RECREATIONAL
OFF-HIGHWAY
VEHICLE
ASSOCIATION

Re: ANSI/ROHVA 1-201X

On behalf of the Recreational Off-Highway Vehicle Association (ROHVA) Technical Advisory Panel, I write in response to your letter regarding the American National Standard for Recreational Off-Highway Vehicles, ANSI/ROHVA 1-201X.

Figure A¹

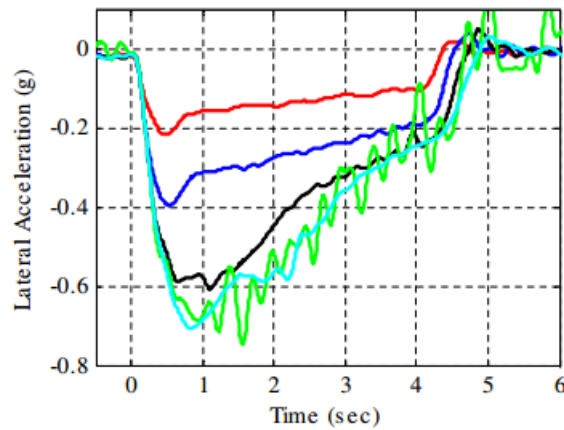
Moreover, even after filtering the data, the lateral acceleration curve, which is used to determine pass-fail in the Lateral Acceleration J-Turn, is a wavy line that varies between multiple tests. See, e.g., Figure A. This wavy line can change due to several factors such as tire tread, track temperature, equipment used, and where the equipment is mounted.

Figure B²

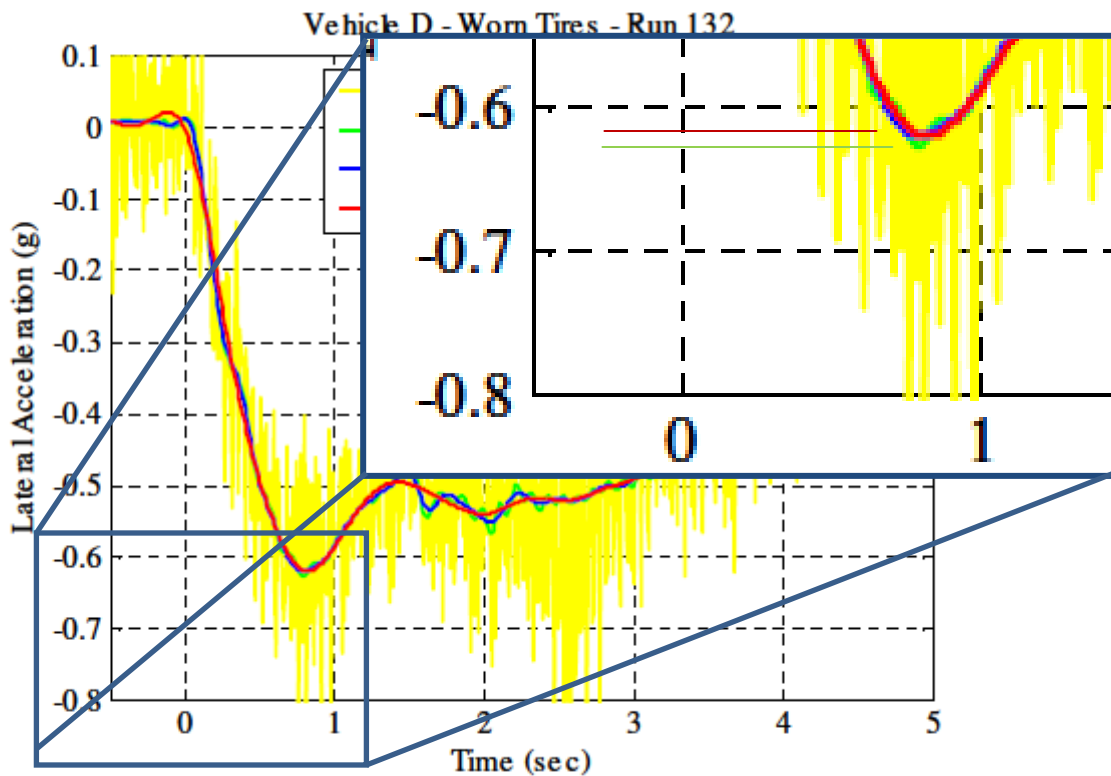
In addition, the filter and the subjective filtering technique utilized during the post-processing of the data has a material effect on the precision of the line and ultimately the value selected as the “peak lateral acceleration.” For example, in its original ROV testing for CPSC, SEA used a 5 HZ 8th Order Butterworth filter. See SEA (April 2011) at 24. In its lateral stability repeatability testing, in contrast, SEA used a 2 HZ Butterworth filter. See “Repeatability Testing of Four Recreational Off-Highway Vehicles,” CPSC Contract CPSC-D-11-0003, SEA, Ltd. Report to CPSC, September 2013 (“SEA (September 2013)”), at 2. The 2 HZ filter averages the actual measurements more significantly than the 5 HZ filter and eliminates the peaks and valleys of the trace. See, e.g., Figure B. This is problematic when “peak lateral acceleration” is the pass-fail metric.

Figure C

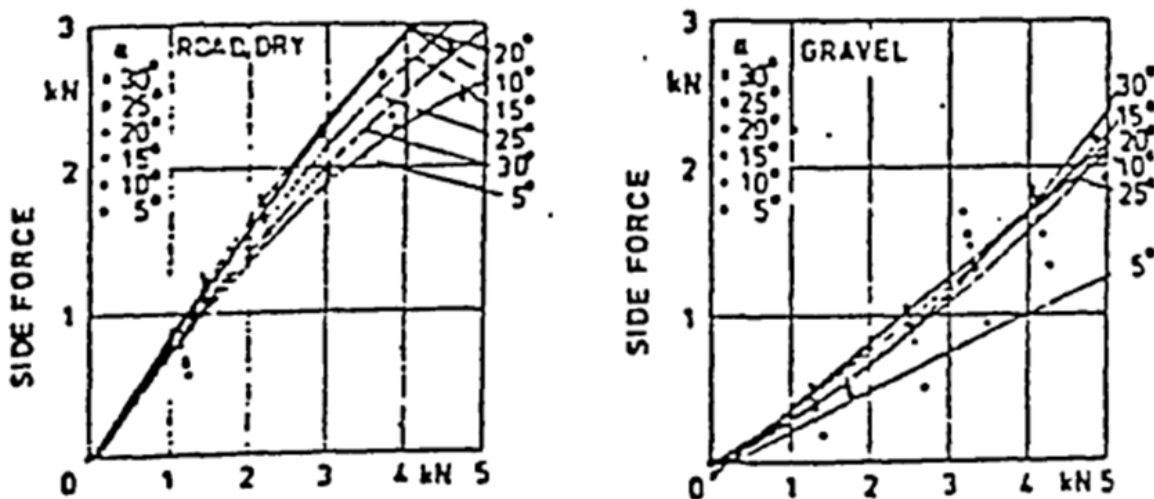
Figure C is taken from “Lateral Tyre Forces on Off-Road Surfaces”, El-Razaz, 1988 and shows on the left the typical convex characteristic for dry pavement with an entirely different concave characteristic on, for example, gravel. This complete reversal of the character of load sensitivity means that the handling character measured on dry pavement has at best a tenuous relationship to the handling character achieved off-highway in the intended operating environment.

Figure D⁵

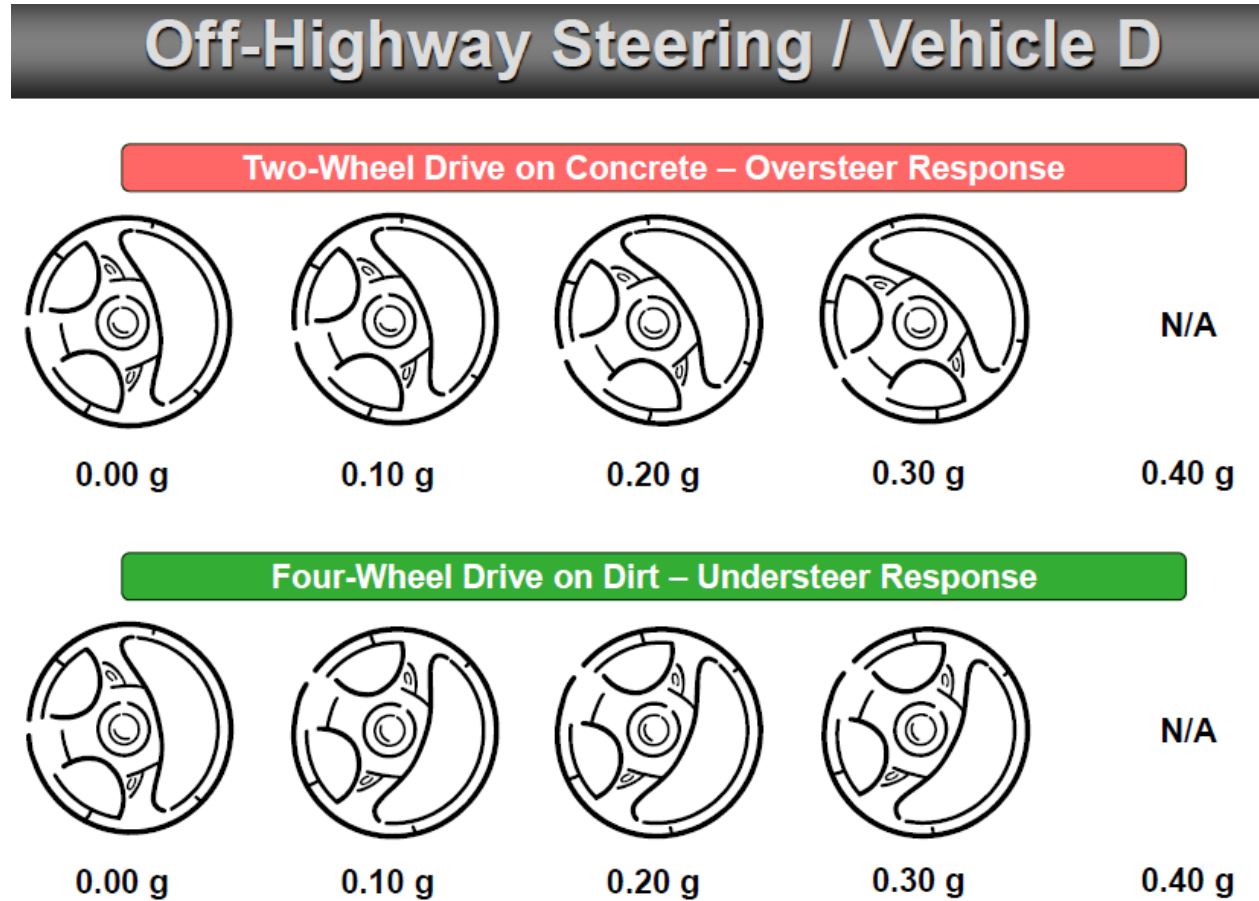
Second, the real world consequences of different understeer gradients, as measured by the required steering input to stay on path, are minor and, based on Brown (2012), equally appealing to the operator. Figure D, presented to CPSC staff by ROHVA on November 10, 2011, illustrates both the differences in performance by surface and the minor change in required input.

Figure E

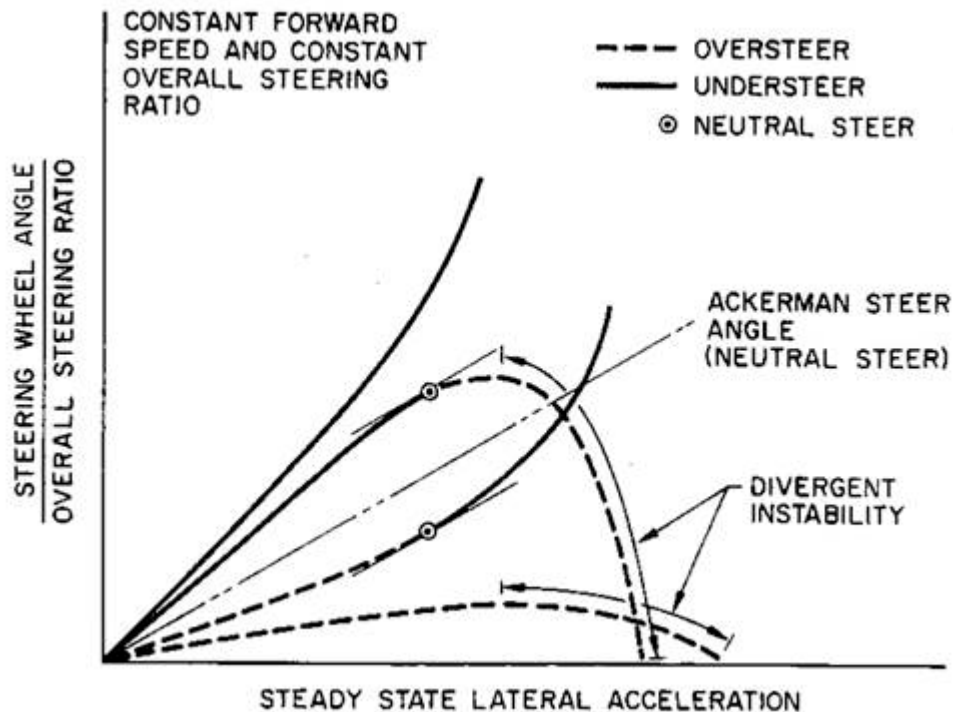
For these reasons, ROHVA continues to oppose a pass-fail standard associated with understeer gradient. Compare Figure F (below) with Figure E (above) taken from Gillespie’s “Fundamentals of Vehicle Dynamics”. This figure is associated with a constant speed test (rather than a constant radius test) and demonstrates that:

- i. oversteer vehicles can be stable; and
- ii. the transition from understeer to oversteer in any case does not mark the onset of divergent instability, which instead comes at a higher lateral acceleration (this transition being more readily visualized with the constant speed test).

Figure F

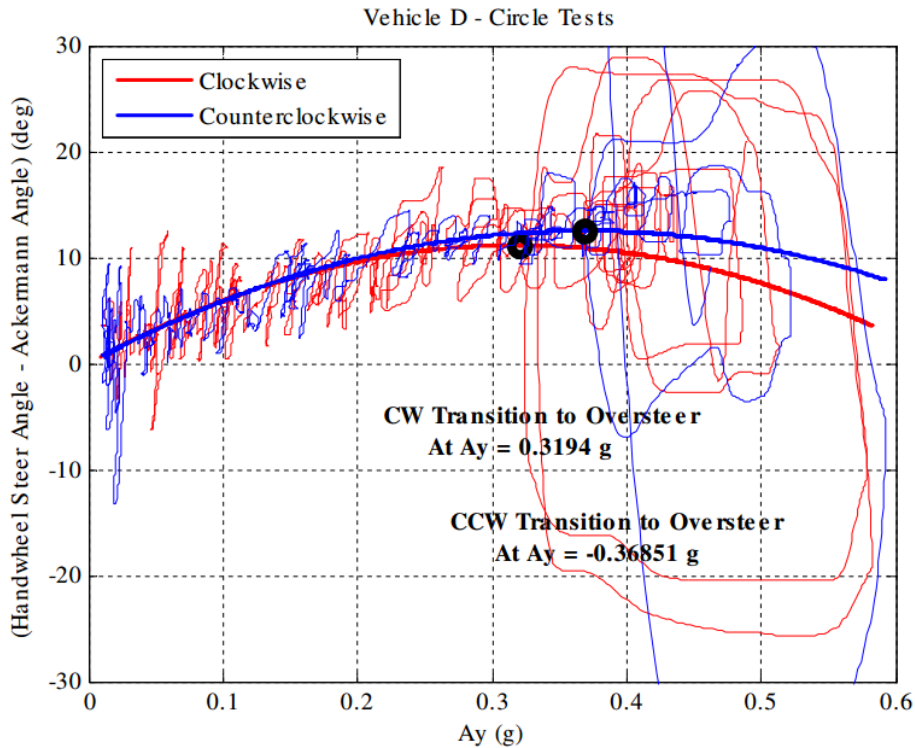
Moreover, measuring and plotting the understeer gradient for an ROV is not precise and generally not repeatable, and thus is not an appropriate metric for a standard. To demonstrate this situation, see Figure F from the report prepared by CPSC's contractor, SEA Ltd. Specifically, the raw data create an erratic trace line. The regression line that subsequently is fitted is the result of the post-processing interpretation of the data, which can vary widely depending on the analysis employed.

As such, understeer gradient is not appropriate for a pass-fail standard. The use of a polynomial function as shown in Figure F is entirely arbitrary and has no known relationship to the behavior of pneumatic tires, see for example "Tire and Vehicle Dynamics", 3rd Edition 2012 by Pacejka, in which complex functions are used to represent the non-linear behavior of vehicle tires on pavement, the vehicle behavior being the sum of the tire forces interacting with the mass and inertia of the vehicle in a readily understood manner, as described in, for example, Milliken & Milliken "Race Car Vehicle Dynamics", 1995. The extremely gentle curvature of the dataset along with the high degree of unavoidable noise in the data (due to tire tread lugs as described previously) mean that the accurate location of a turning point in the underlying data using such a method is susceptible to variations in noise and details of the curve fitting algorithm, as well as the actual function being fitted. These factors create an unsatisfactory level of uncertainty for a pass-fail standard.
